SUBJECT: 18th and Northwestern Parkway Storage Basin
Minor Project Modification
IOAP Project No. L_SO_MF_190_S_09B_B_A_8

Subject: Chenoweth Hills WQTC Elimination, Chenoweth Run and Chippewa PS Improvements
Minor Project Modification
IOAP Project No. S_JT_JT_NB01A_M_03_C
DOJ Case No. 90-5-1-1-08254

Subject: Goose Creek PS Phase 1 – Devondale Wet Weather Storage
Minor Project Modification
IOAP Project No. S_MI_MF_NB04_M_03_B
DOJ Case No. 90-5-1-1-08254

Subject: St. Rene Road Pump Station In-Line Storage
Minor Project Modification
IOAP Project No. S_FF_CH_NB01_S_09A_C_A
DOJ Case No. 90-5-1-1-08254

Middle Fork Sewershed
Goose Creek PS Improvements &
Wet Weather Storage 1
Devondale Wet Weather Storage

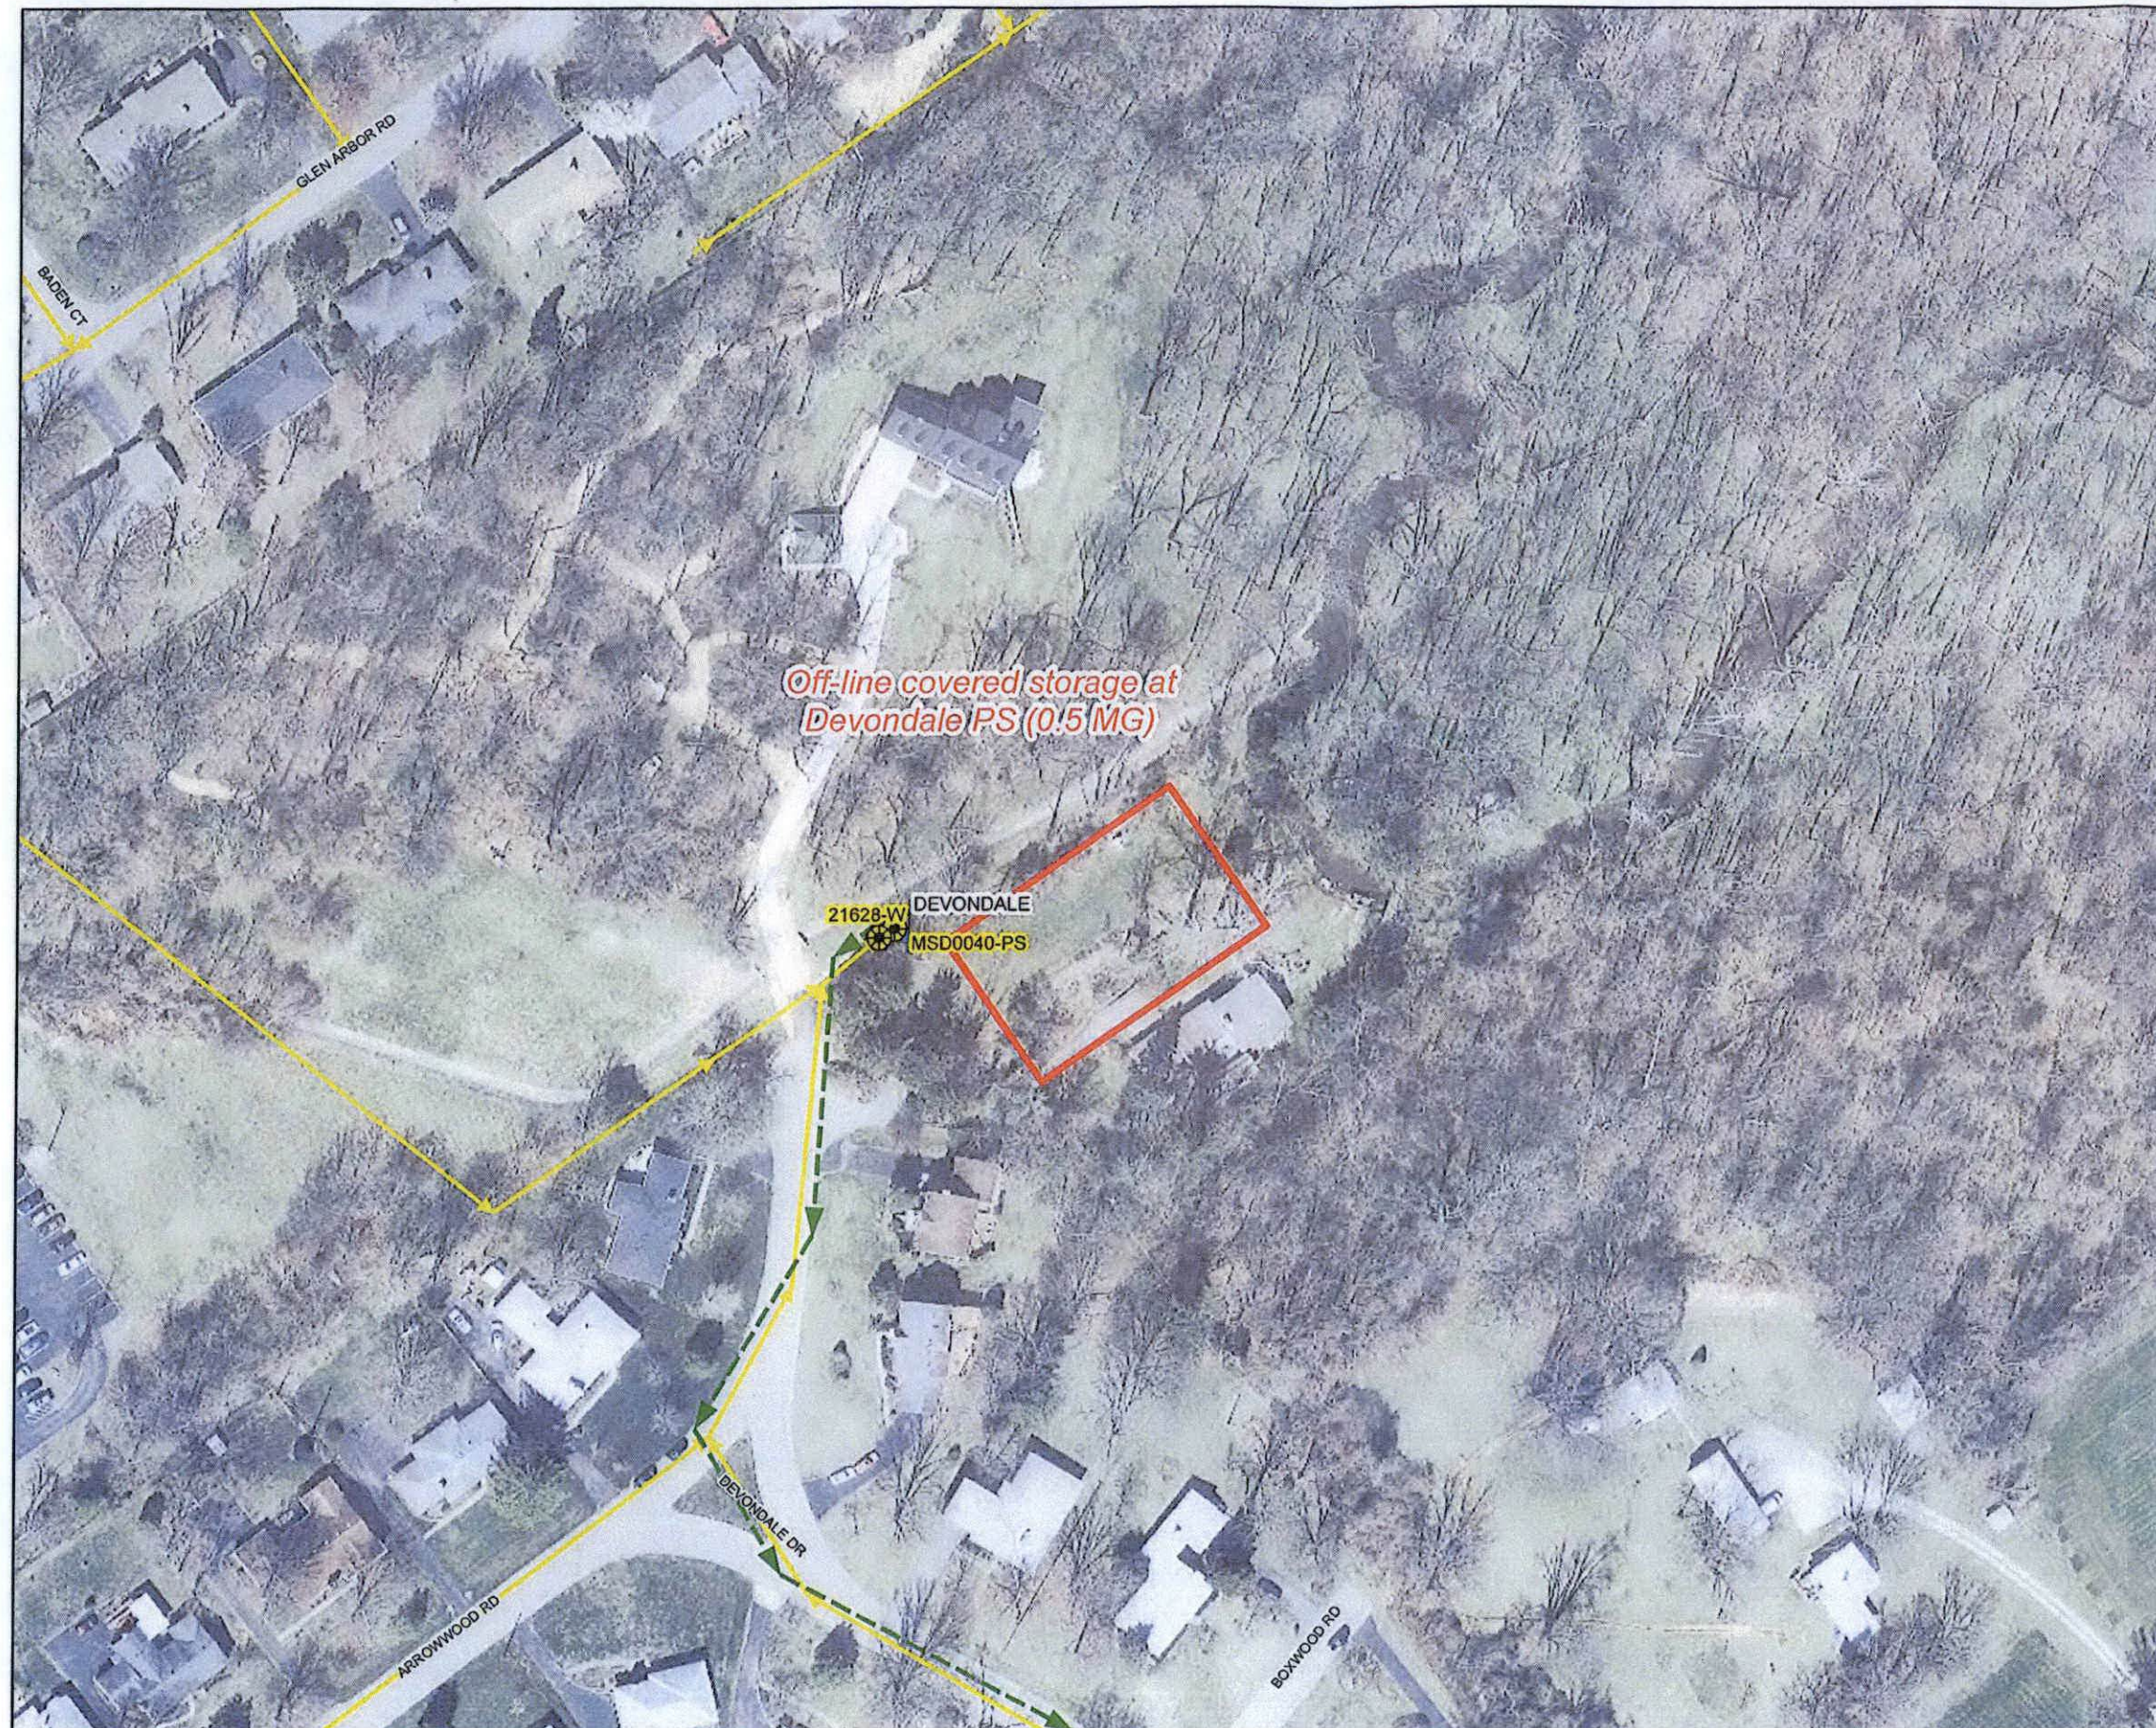
The project modification proposed eliminates the Devondale Pump Station by constructing 1,334 LF of new 12-inch diameter gravity sewer from the current pump station to the site of the existing Bancroft Water Quality Treatment Center (WQTC). MSD plans to eliminate the Bancroft WQTC as part of MSD's overall program to eliminate all small WQTCs. This will be accomplished by constructing a new 0.33 MGD pump station to eliminate the WQTC. A 0.25 MG wet weather storage basin at the Bancroft WQTC site will be constructed to attenuate wet weather peak flows. Flows from the Bancroft service area and the Devondale Pump Station service area will be consolidated and pumped through a 6-inch diameter force main back to the current discharge location of the Devondale Pump Station. Flows will be treated at the Morris Forman WQTC. No change in the project schedule is proposed.

For your reference, a copy of the current project fact sheet and map from the 2012 IOAP Modification are in Attachment A. A new project fact sheet and map reflecting the pump station elimination have been provided in Attachment B.

Project Description This project eliminates the Devondale Pump Station by constructing 1,334 LF of new 12-inch diameter gravity sewer from the current pump station to the site of the existing Bancroft Water Quality Treatment Center (WQTC). The Bancroft WQTC will be eliminated by constructing a new 0.33 MGD pump station. A 0.25 MG wet weather storage basin at the Bancroft WQTC site will be constructed to attenuate wet weather peak flows. Flows from the Bancroft service area and the Devondale Pump Station service area will be consolidated and pumped through a 6-inch diameter force main back to the current discharge location of the Devondale Pump Station.
